BRACKETT AVE., PEAKS ISLAND

84-J-3-11

APPLICATION FOR AMENDMENT TO PERMIT

1st Floor Framing  
1/4" = 1'

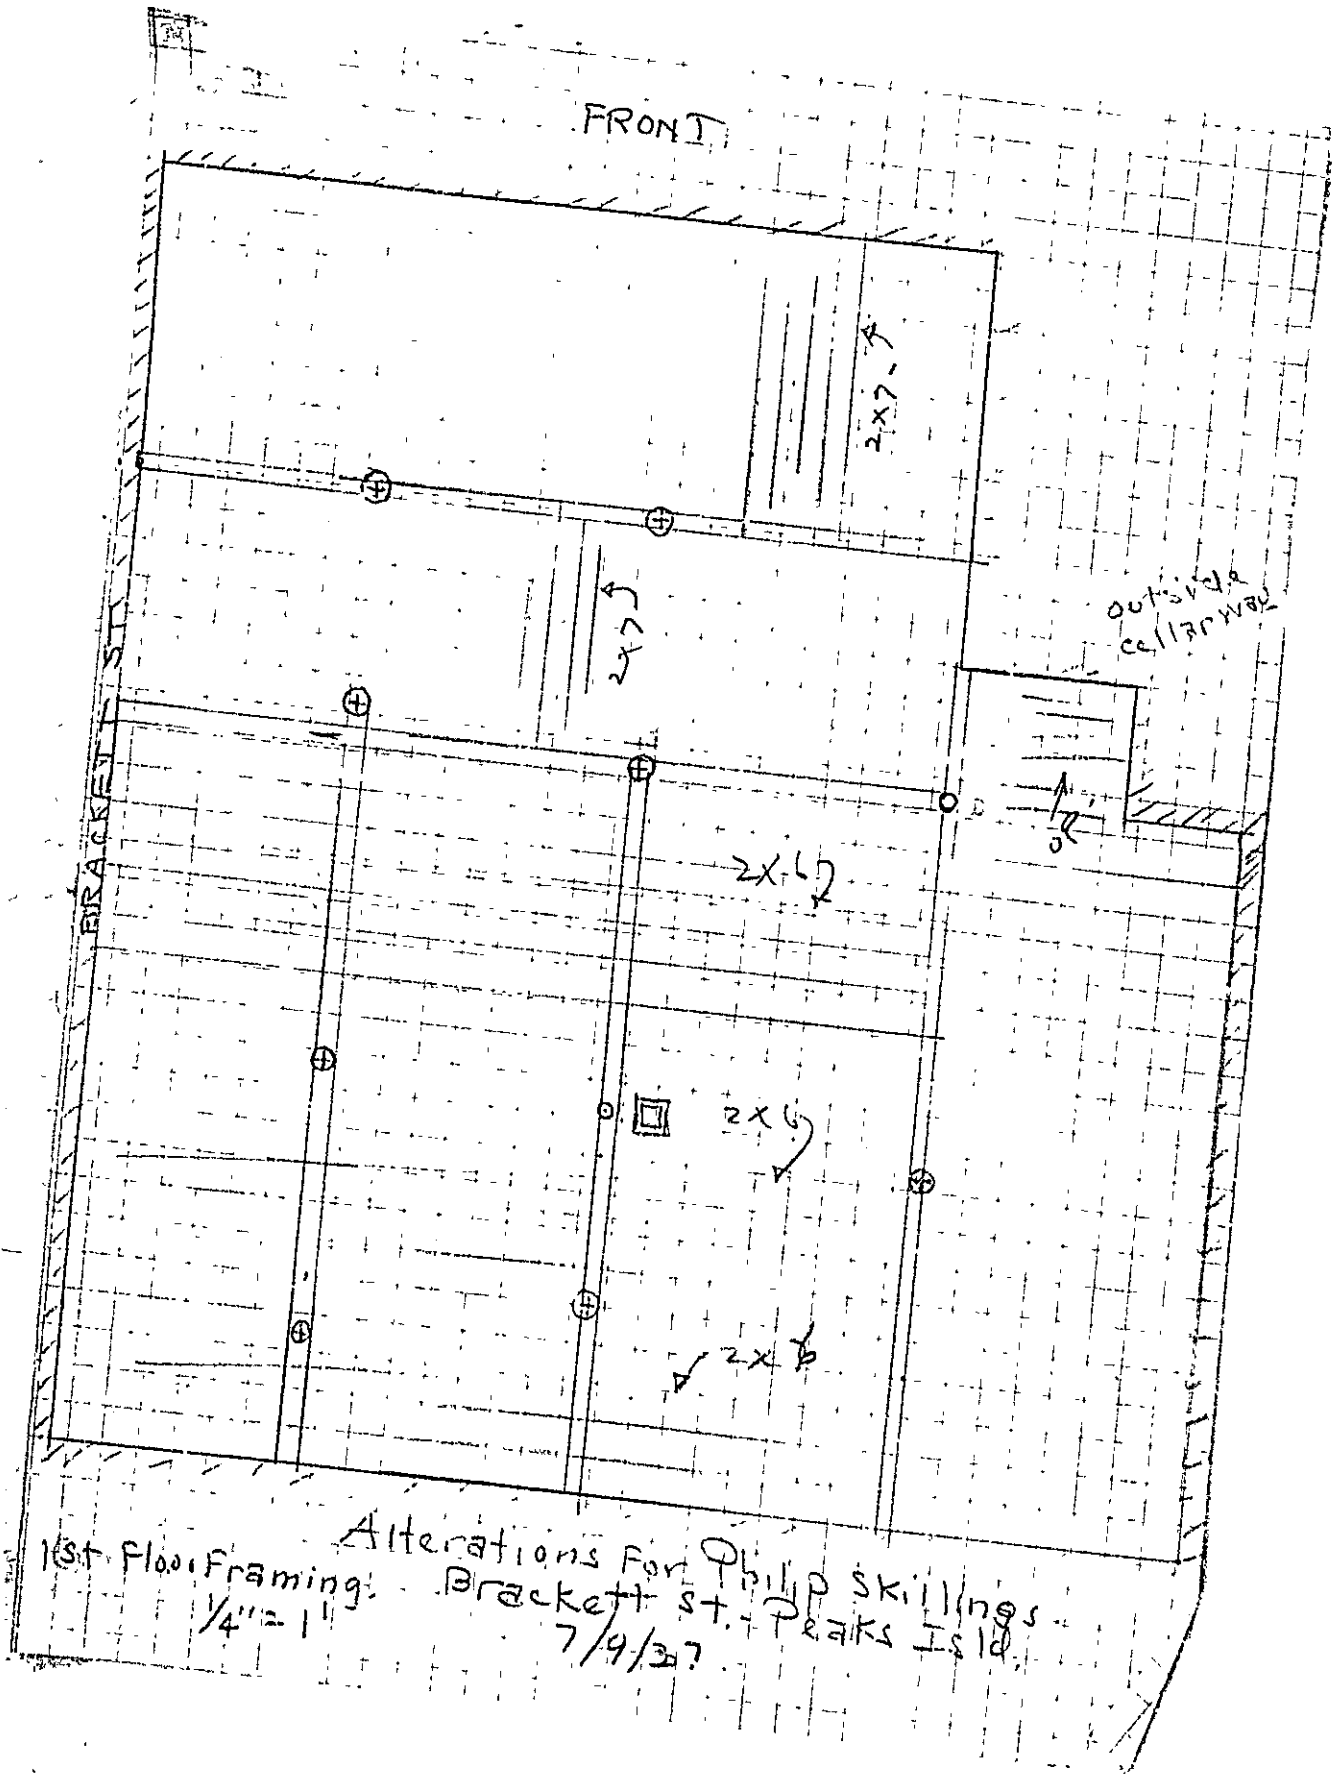
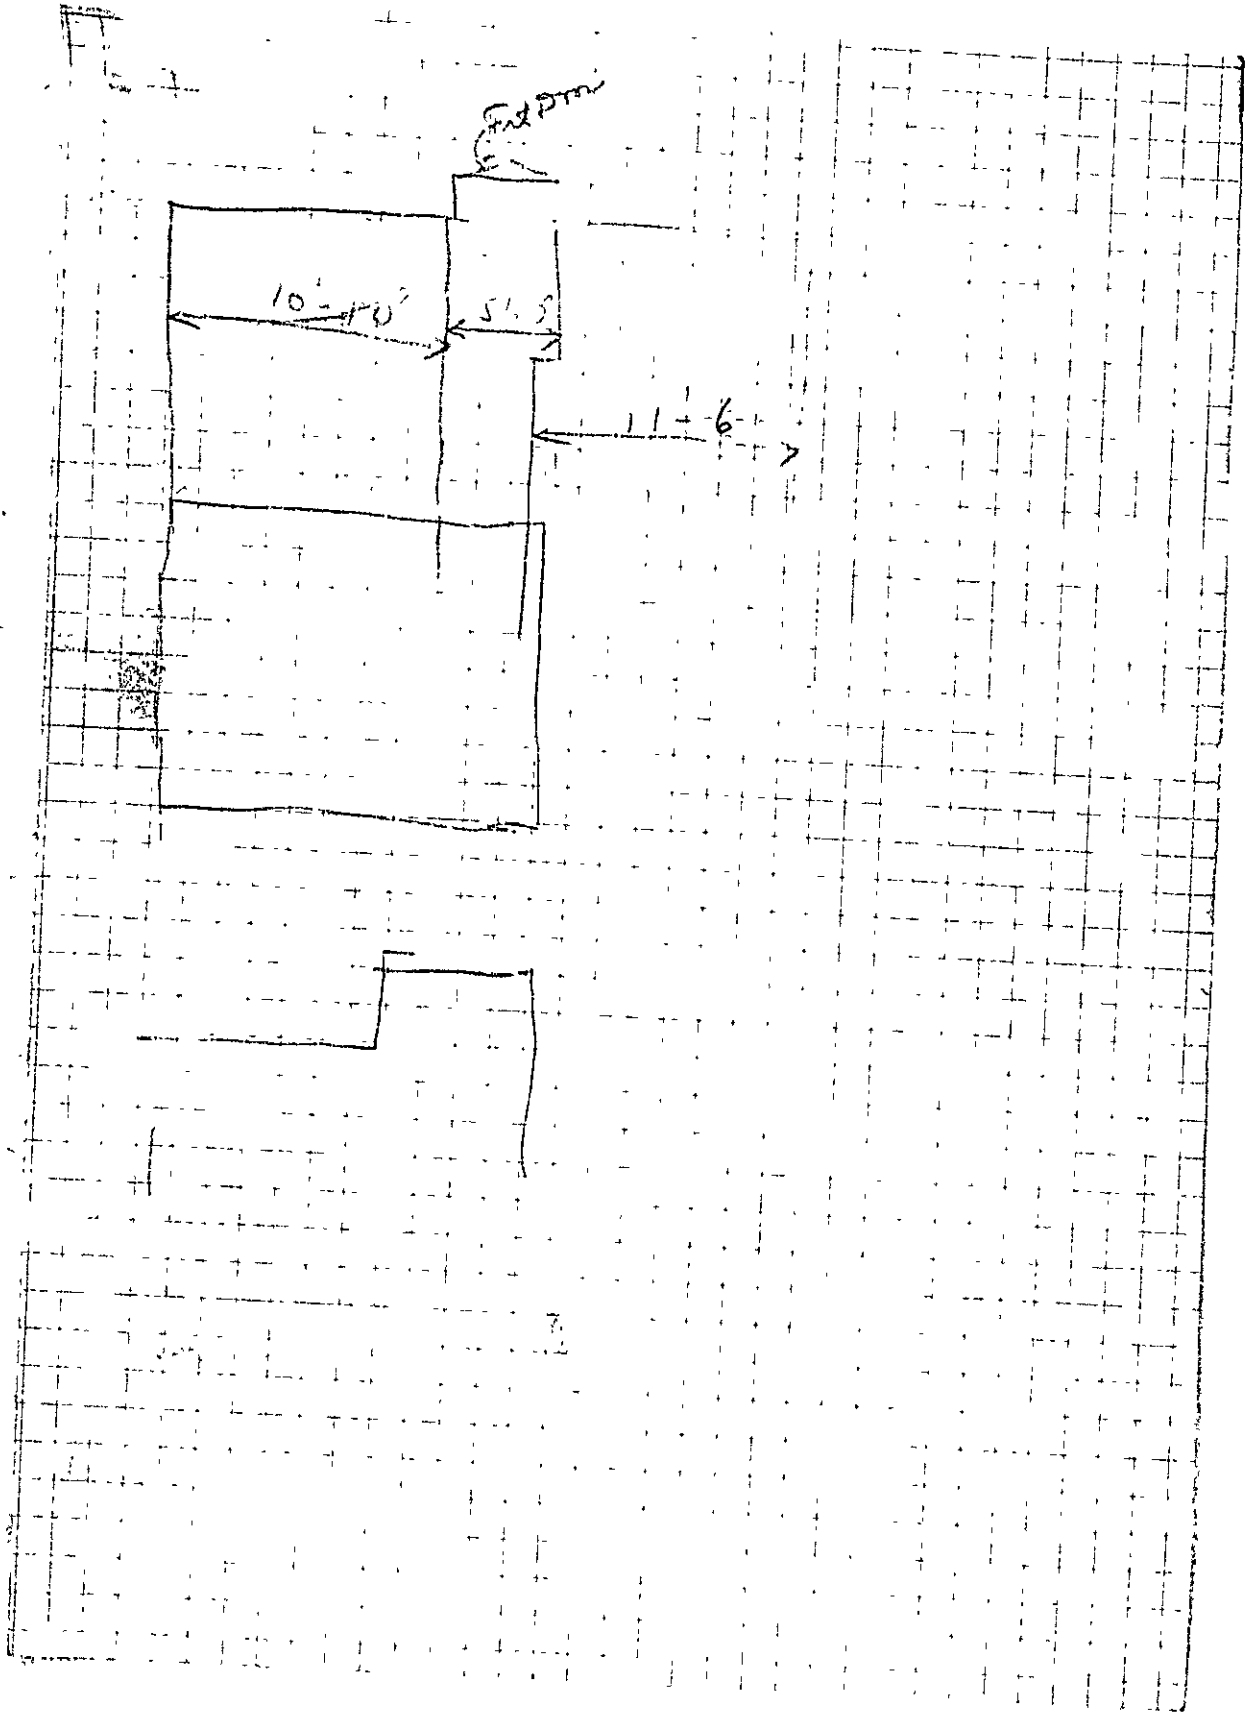
Upon examination of the dwelling house owned by Phillip Skillings on Brackett Street, Peaks Island pertaining to which you have applied for a building permit to cover a substantial alteration in the roof structure, we find the framing and the situation as to supporting partitions, etc. substantially different from that indicated by yourself.

You explained that you proposed to support the joists of the new flat roof deck on a bearing partition which now exists approximately in the middle of the easterly half of the building; at the middle of the deck upon a bearing partition which now exists beneath the valley where the two gables and roofs meet; and by new girders to be run at the ridge of the westerly half of the house, these girders to be supported upon posts which would run down on to existing bearing partitions which run at right angles to the front of the dwelling.

It may be that there is an adequate bearing partition supported in the cellar upon adequate joists beneath the valley where the gables and roofs meet, but we can discover no continuous bearing partition existing beneath the ridge of the easterly half of the house and instead of having any existing girder in the cellar beneath where this carrying partition would come, the carrying girders in the cellar run the other way, that is at right angles to the front of the house. The partitions in the westerly half of the house, which you evidently intended to support the posts which would in turn support the new girders under the ridge, are not of sufficient stiffness and size of construction to be classified as carrying partitions and have no girders beneath them in the cellar, the girders in the cellar below this portion of the building running parallel with the front. You have not shown the size of the proposed new girders beneath the ridge on the westerly half of the house.

We are desirous of issuing this building permit, but my duty requires that I withhold the permit until some definite, detailed means is established for supporting the additional loads of this new flat roof. I feel that we must have at least a skeleton framing plan which will show all details in adequate fashion to support the new loads according to Building Code standards. This information should be on plans or diagrams and to scale. The plan furnished is not to scale and gives the wrong impression; and you have not shown locations of the bearing partitions which you propose to use as they will come over the supporting members in the cellar.
